10/816,986

Office Action Summary	Application No. 10/816,986	Applicant(s) ISOGAI, YOSHIHIRO	
	Examiner Gregg Cantelmo	Art Unit 1795

DETAILED ACTION

第 3 図

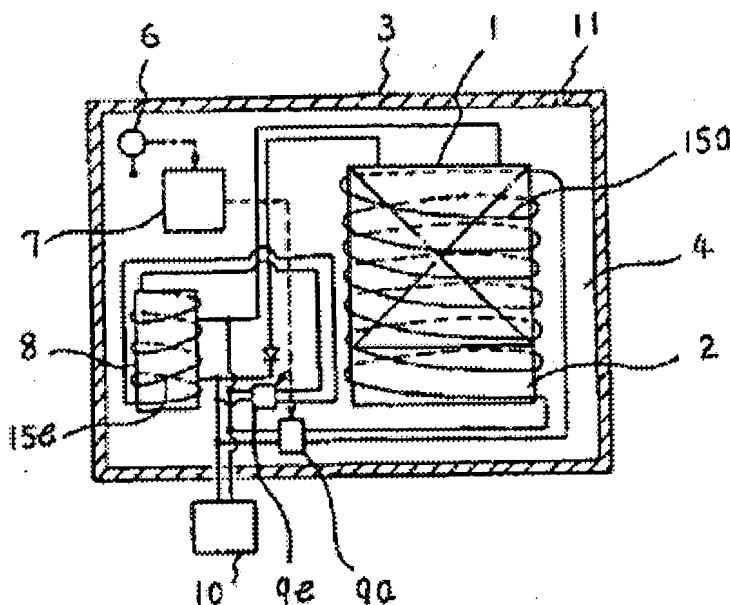
JP '967 discloses a hybrid system comprising: a first heating device 15b that heats the battery 8, a second heating device 15a that heats the fuel battery 1 using electricity of the battery and a control device 7 connected to switches 9a and 9b which is configured to selectively drive the heating system of the fuel cell (Fig. 3 as applied to claims 1 and 19).

The fuel battery 1 is a stack of cells. (as applied to claim 3).

The first heating device about the battery is driven by electricity generated by the battery (as applied to claim 4).

The heater 15a is mounted onto the fuel cell stack 1 (as applied to claim 20).
